STAFF REPORT

Application for Tentative Partition Plat Review Planning File PA-01-18

DATE OF REPORT:	March 7, 2018
FILE:	PA-01-18
TYPE OF APPLICATION:	Land Division Tentative Plat to create a Two-Lot Partition.
REVIEW BODY:	Staff (Type I-L process)
PROPERTY OWNER:	Fred Molodih; 360 Cindy Lane; Mt. Angel, OR 97362
APPLICANT:	TS West LLC; P.O. Box 436; Mt. Angel, OR 97362
SURVEYOR/ENGINEER:	Jason Cota; K&D Engineering Inc.; 276 Hickory Street NW; Albany, OR 97321
ADDRESS/LOCATION:	2618 Geary Street SE
MAP/TAX LOT:	Linn County Assessor's Map No. 11S-03W-17BC Tax Lot 00800
ZONING DISTRICTS:	RS-6.5 - Residential Single-Family
COMPREHENSIVE PLAN DESIGNATION:	Residential – Low Density
LAND AREA:	14,000 square feet
EXISTING LAND USE:	Single-Family Dwelling
SURROUNDING ZONING:	North: RS-6.5 - Residential Single-Family South: RS-6.5 - Residential Single-Family East: NC, Neighborhood Commercial West: RS-6.5 - Residential Single-Family
SURROUNDING USES:	North: Single-family residential South: Single-family residential East: Single-family residential West: Single-family and multi-family residential

**TENTATIVE REPLAT MAP
FOR
TS WEST LLC
LOCATED IN**

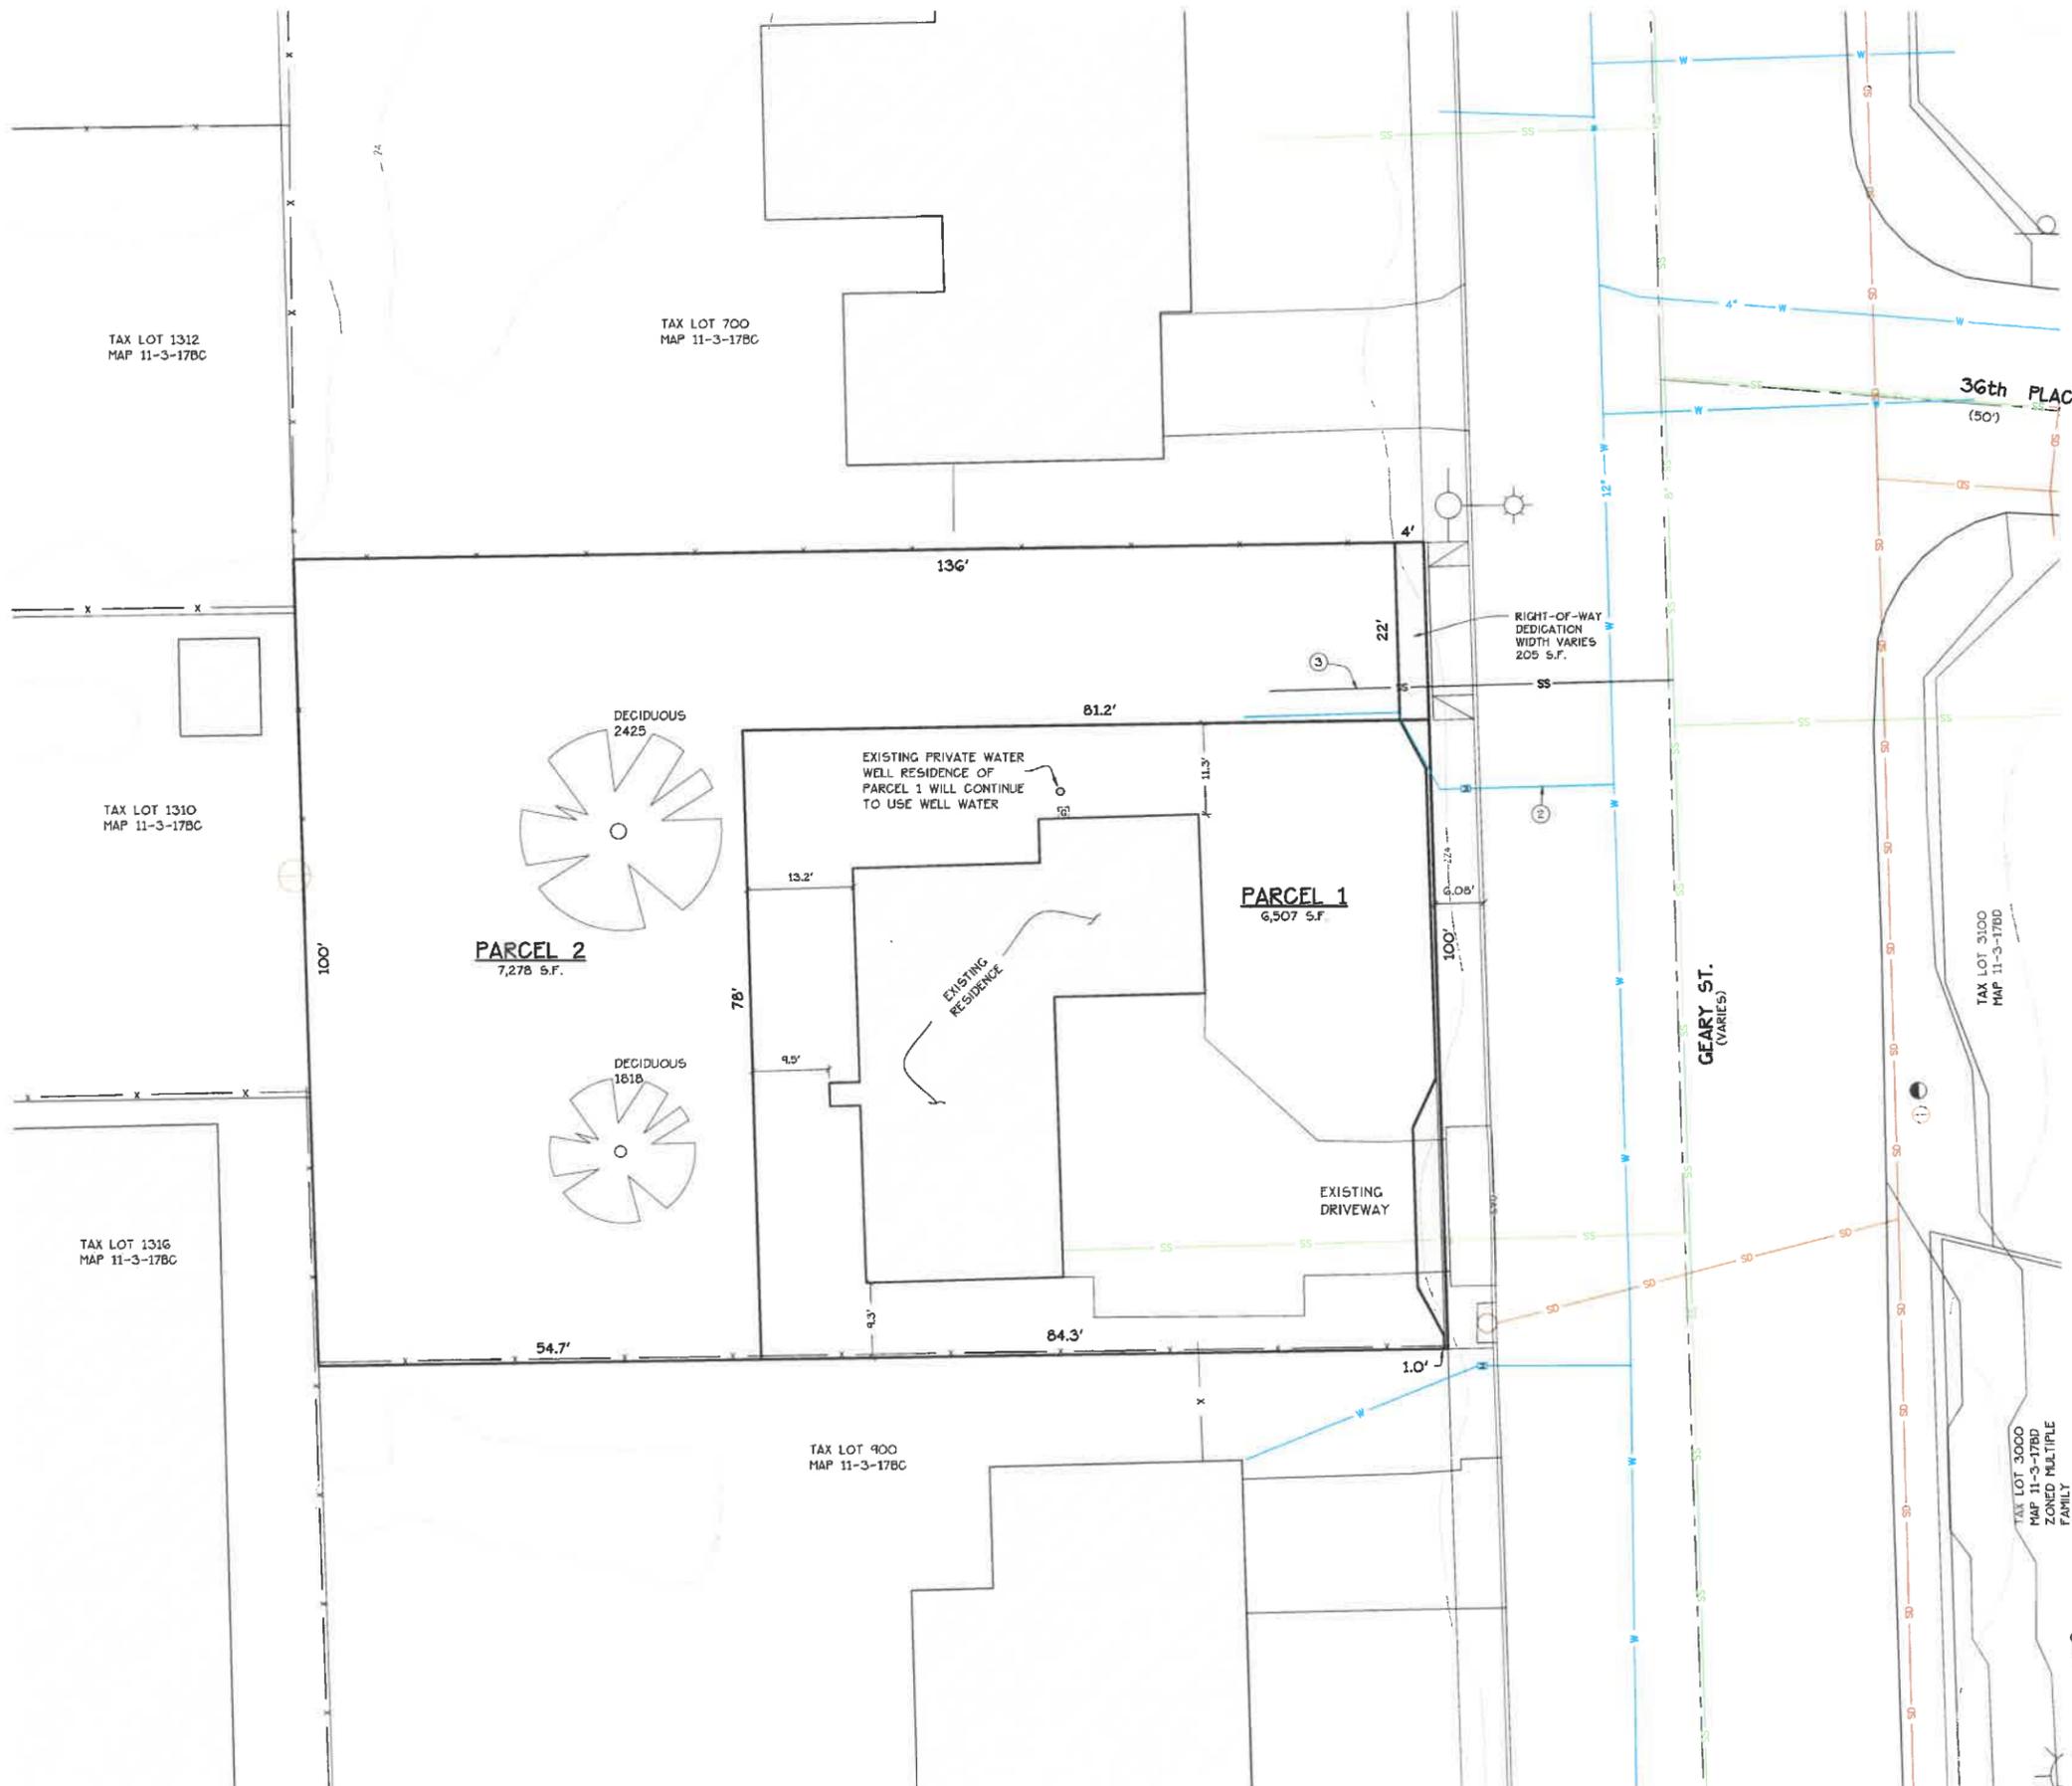
- 1.3 Parcel 1 is proposed to retain an existing single-family home on a 6,507 square foot lot, which meets the lot size standard for a single-family home. Parcel 2 is proposed to be 7,278 square feet, which meets the lot size standard for single-family development.

- 1.4 **Minimum Lot Dimensions.** The minimum dimension for parcels in the RS-6.5 zone is 50 feet wide and 80 feet in depth.
- 1.5 Parcel 1 is proposed to be 78 feet wide and approximately 81 feet deep. Parcel 2 is proposed to be 50 feet wide and 100 feet deep. Both parcels, as proposed, meet the minimum dimensional standards for the RS-6.5 zone.

1.8 As noted in findings 1.1 through 1.6, the proposed lots comply with the minimum requirements of the underlying zoning district; those findings are included here by reference. The house on Parcel 1 will remain. The dimensions of Parcel 2 (54.7 feet by 100 feet) provide an adequate building envelope for a dwelling; therefore, there will be no foreseeable difficulties in obtaining building permits on the new parcel. This criterion is met.

1.12 The side yards for proposed Parcel 1 run at a right angle to the public street. Parcel 2 is a “flag lot” configuration, so the side yards do not abut the public street. This criterion is met.

1.13 The proposed partition will create one flag lot, Parcel 2, to provide access to the proposed buildable area behind Parcel 1.

- 4.4 The Geary Street right-of-way line along the frontage of the site is six feet behind the face of curb. The standard width for curbside public sidewalk along arterial streets is seven feet, with the back of the walk being located six inches from the right of way line.

- 5.7 Future development on the proposed new parcel (Parcel 2) must be connected to the public water system.
- 5.8 The applicant is proposing to utilize an existing water service for the new parcel. A private utility easement is proposed for the section of private water line serving Parcel 2 that will cross over a portion of Parcel 1.

- 5.9 Because the parent parcel has never been connected to the public water system, a water connection charge will be due for the existing public water main in Geary Street. This charge is due before the City will approve the final partition plat.

- Condition 1:** Prior to recording the partition plat, the applicant shall construct or financially assure the construction of public sidewalk to City standards across the development frontage on Geary Street.
- Condition 2:** Prior to or with the recording of the partition plat, the applicant shall dedicate right-of-way along the site's frontage on Geary Street for installation of public sidewalk to City standards. Dedication may be as shown on the tentative plat map or there may be dedication of two feet of right-of-way together with a four-foot public sidewalk easement.

- Condition 3:** Before the City will approve the final partition plat, a water connection charge will be due for the existing public water main in Geary Street.
- Condition 4:** A private utility easement for plumbing shall be provided on the final plat over a portion of Parcel 1 for the benefit of Parcel 2.
